Draft Final

Demonstration of Surfactant-Enhanced Aquifer Remediation of Chlorinated Solvent DNAPL at Operable Unit 2, Hill AFB, Utah

June 1997

Figure 3-2

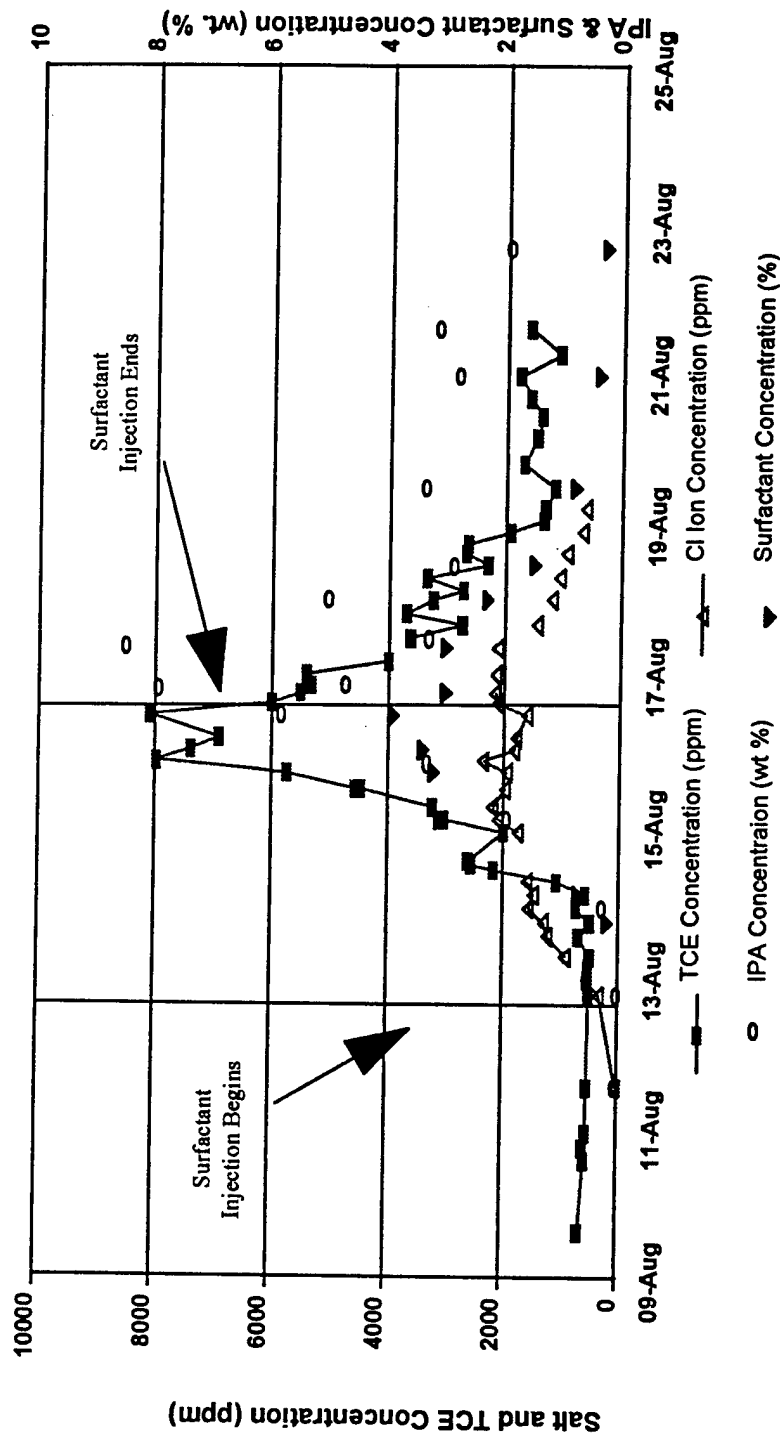
Item	Page	Section/ Paragraph	Line	Comment	Response/Action
1	3-8	Figure 3-2	NA	Correct this figure to show that the stainless steel casing was used for the first ten feet above the well casing.	The figure has been corrected and is attached for review.
2	3-21	Figure 3-7	NA	The labels for the test wells are difficult to read. Provide clear labels for the wells to orient the reader.	The figure has been revised and is attached for review. The well labels have been changed and the shading has been removed to make them more legible. A north arrow and axis labels have been added to orient the reader. The page size has been increased to an 11x17 format.
3	3-28	4	3	The second sentence in this paragraph is duplicated. Correct the text.	The duplicate sentence has been removed.
4	3-29	2	3	Provide a complete reference for Mariner et al., 1997.	The list of references has been updated to include Mariner et al, 1997. The revised Section 10.0 is attached for your review.

Figure 7-9

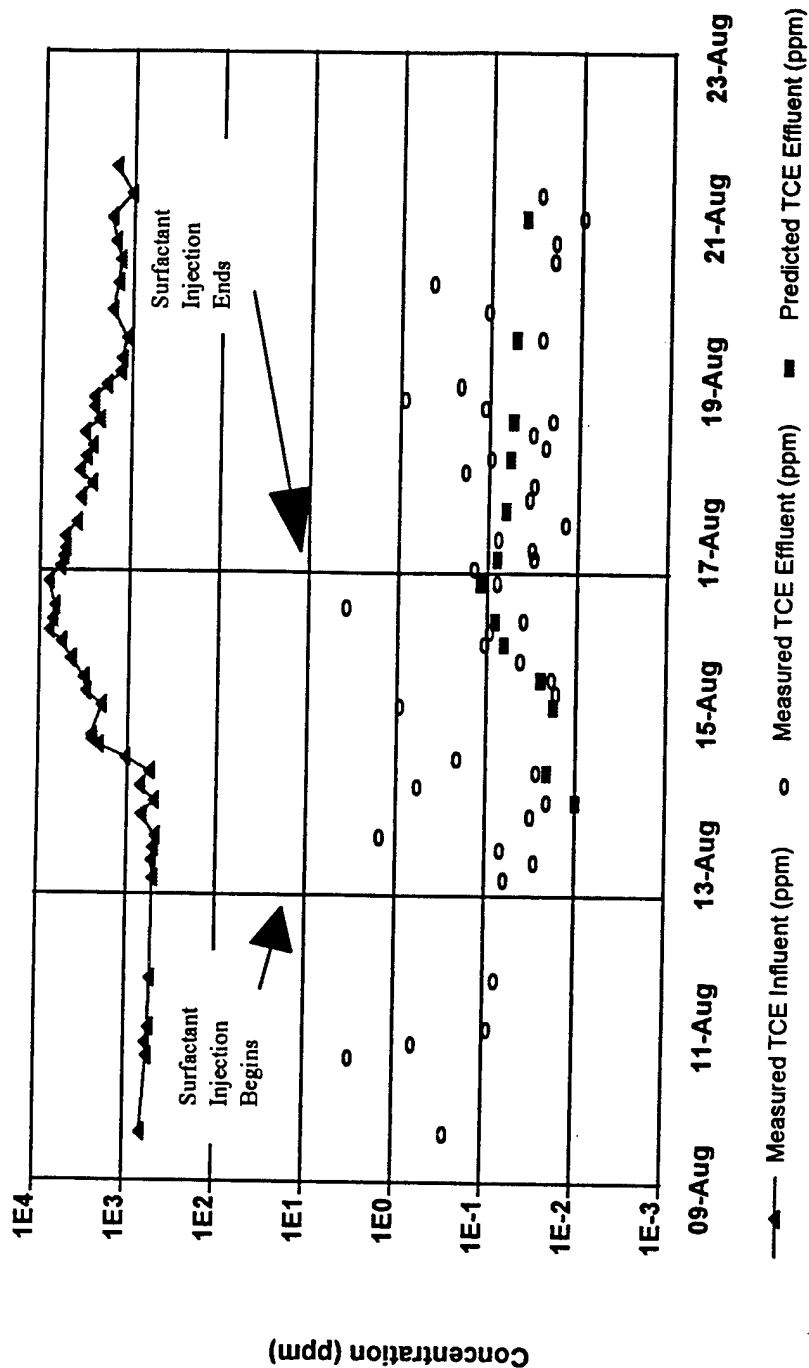
31	7-21	Figure 7-9	NA	No data are provided for isopropyl alcohol concentration, and the symbol is not shown in the legend. Provide the data, and correct the legend.	The graph and legend have been corrected to include isopropyl alcohol. The revised figure is attached for review.
32	7-22	2	4	The text states that baseline (no surfactant) conditions were modeled, but no results are presented. Modify the text to include the baseline modeling results.	The quoted statement is misleading. The sentence stating that baseline modeling had been conducted has been deleted.
33	7-23	Figure 7-10	NA	No data are provided for measured TCE effluent (parts per million), and the symbol is not shown in the legend. Provide the data, and correct the legend.	The graph and legend have been corrected to include measured TCE concentration. The revised figure is attached for review.
34	8-3	4	3	The total demonstration project cost exceeded 1,050,000, and approximately 341 gallons of solubilized residual DNAPL were recovered,	The cost per gallon has been corrected to about \$3000. A discussion clarifying the cost calculation has been added to Section 8.0, and is attached for your review.

Figure 4-5__—Comparison of Normalized Tritium and Surfactant Concentration During Surfactant Flooding in a Column

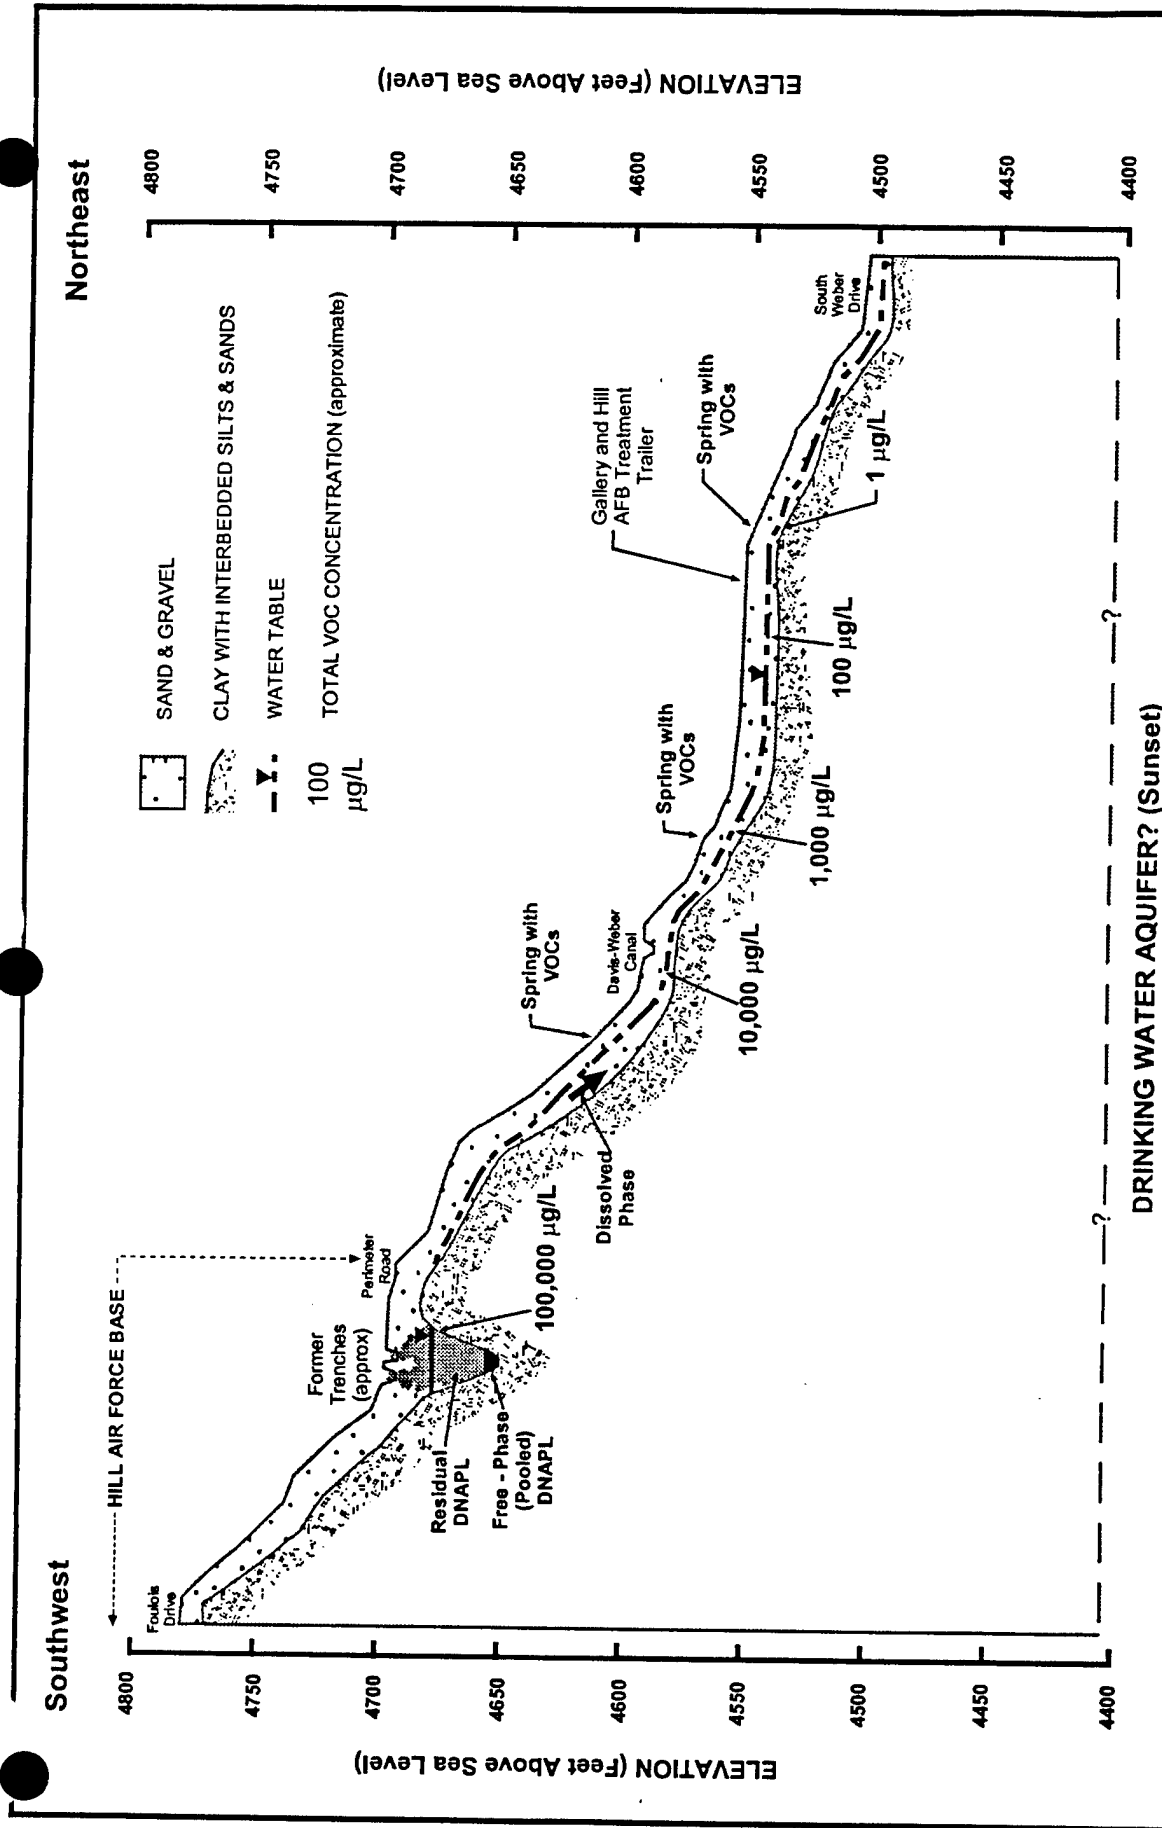
Section 4.1.3.1 Figure 4-4: Symbols for the tracer test data need to be identified.

DATE: 10/09/97		Generalized Cross-Section of OU2 (Modified from Radian, 1992.)	0100200300 Feet Vertical Exaggeration: 4X
WID#: TAF 105 99999			
FILE: HILXSEC.XAR			
 INTERA © 1995 Interagency & Interim Group		Hill AFB, Utah	Figure 2-6

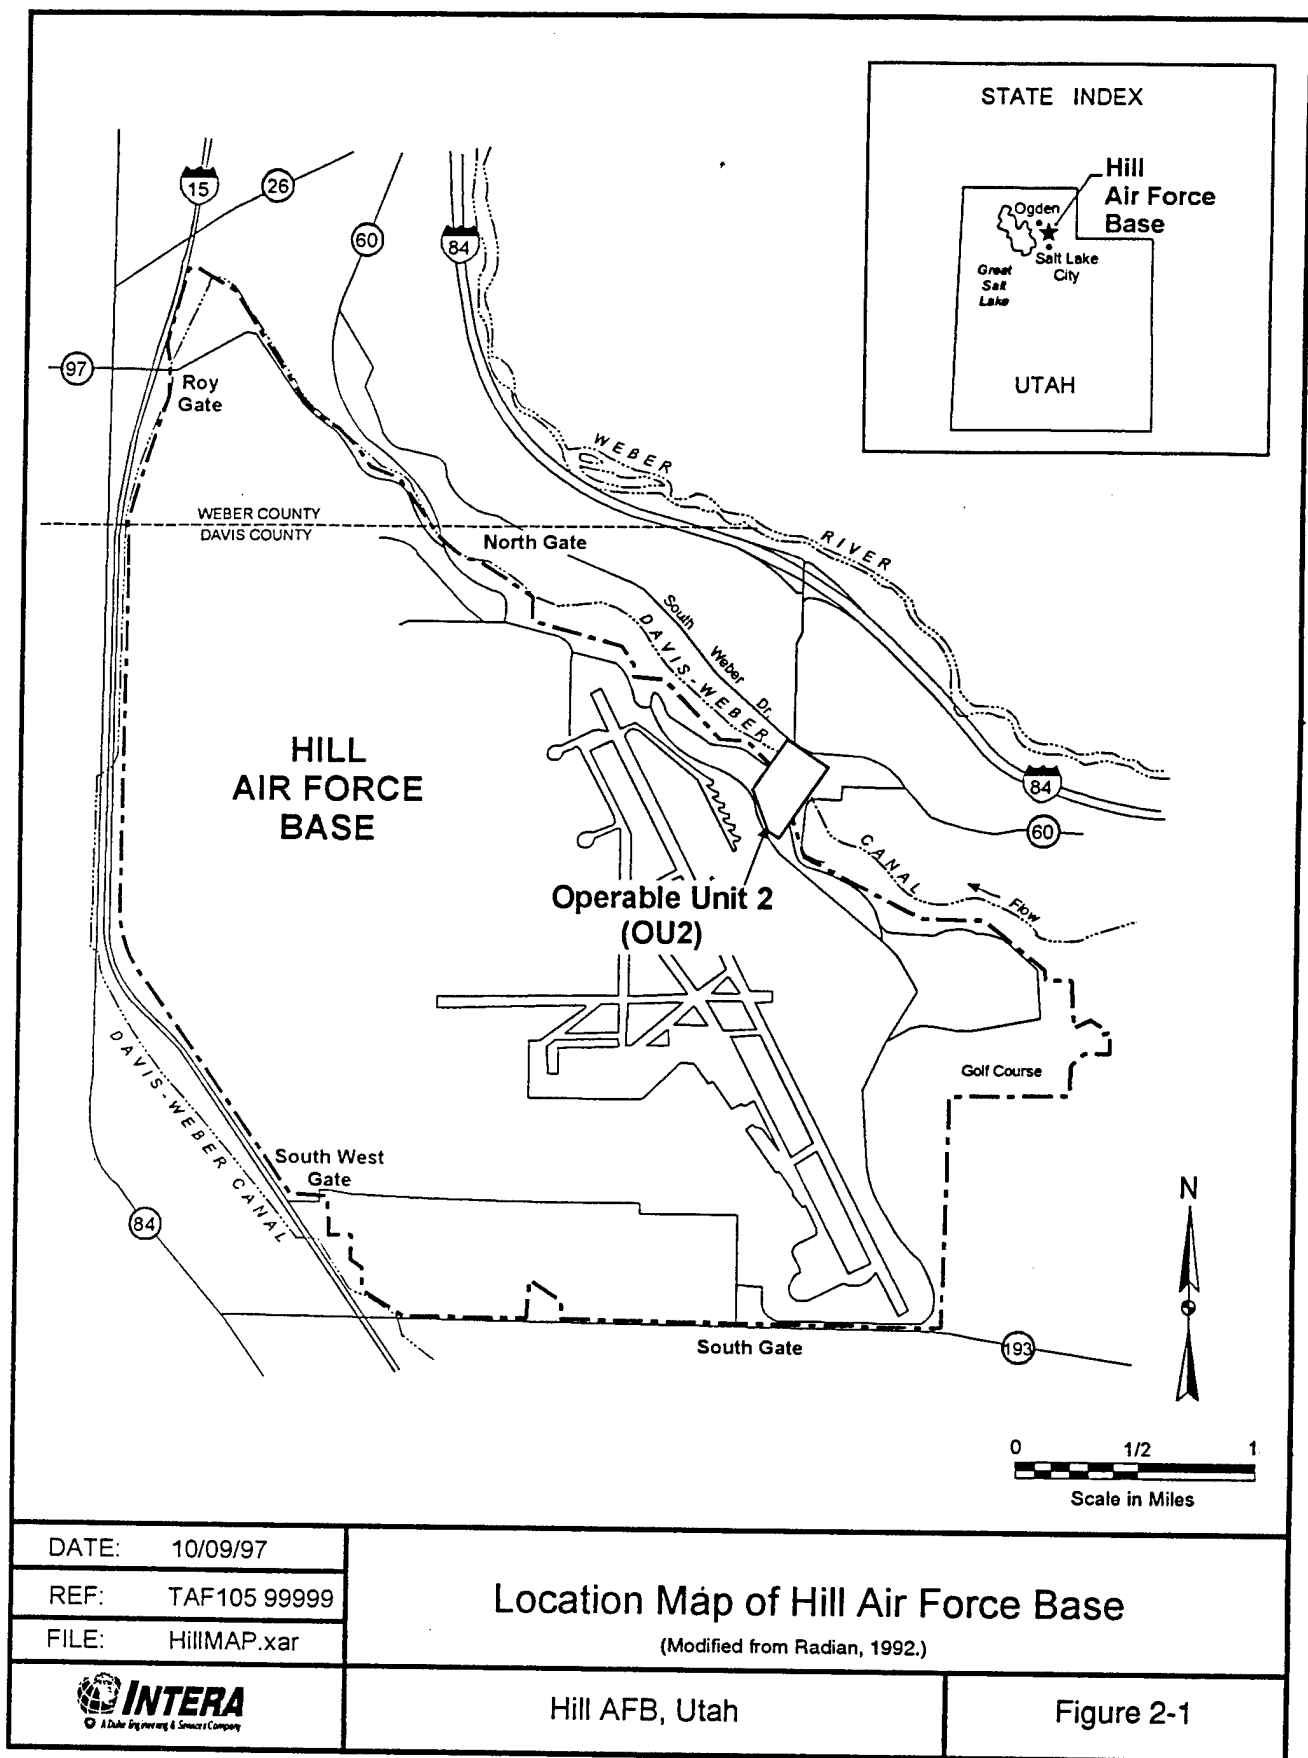
Action/Revision: This figure, now numbered as Figure 2-6, has been corrected to reflect the proper spelling of "Foulois Drive", and is attached for your review. The spelling of "Dissolved Phase" has also been corrected.
